Tobin Park 8-inch Siphon - CIPP Solicitation Number: CO-00266-SM Job No.: 19-4515

ADDENDUM 2 July 26, 2019

TOBIN PARK 8-INCH SIPHON - CIPP

Carelin Dr Sewer Plan Sheet 6 of 8

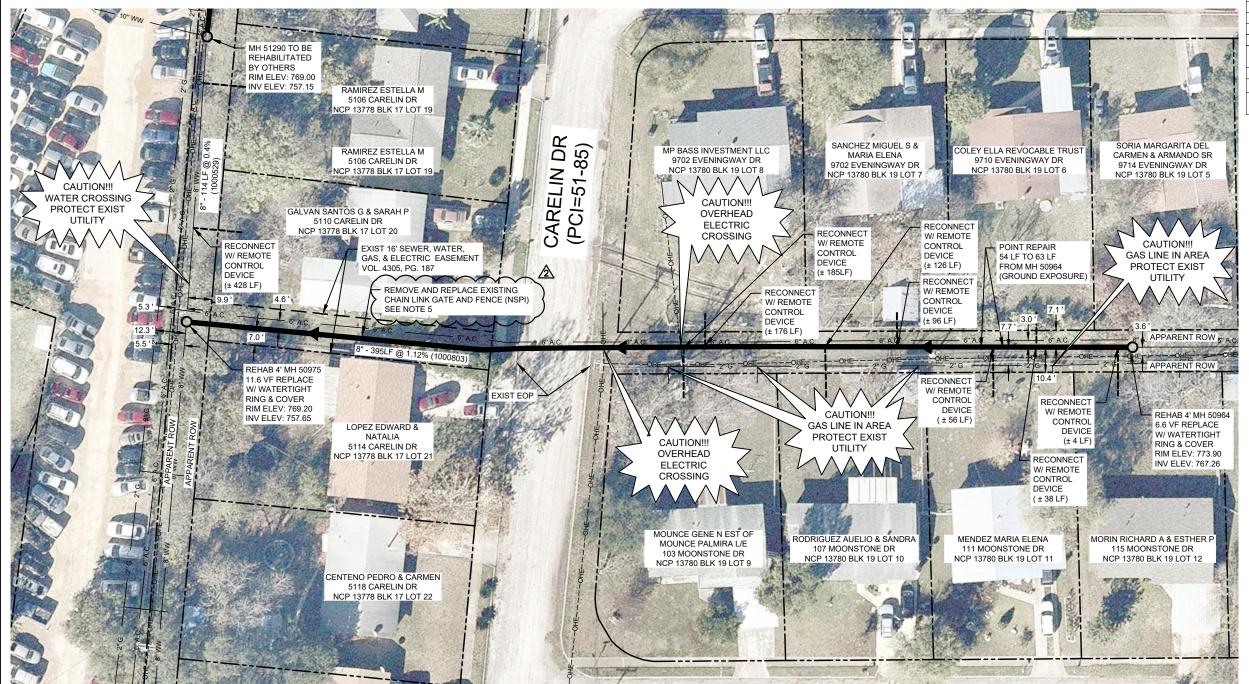
- Carelin Dr Sewer Plan Sheet 6 of 8 Added note to plan sheet to REMOVE AND REPLACE EXISTING CHAIN LINK GATE AND FENCE (NSPI) SEE NOTE 5
- Carelin Dr Sewer Plan Sheet 6 of 8 Added Note 5. CONTRACTOR TO COORDINATE WITH SAWS INSPECTOR AND PROPERTY OWNER PRIOR TO MOBILIZING AT NO ADDITIONAL COST TO SAWS (NSPI).
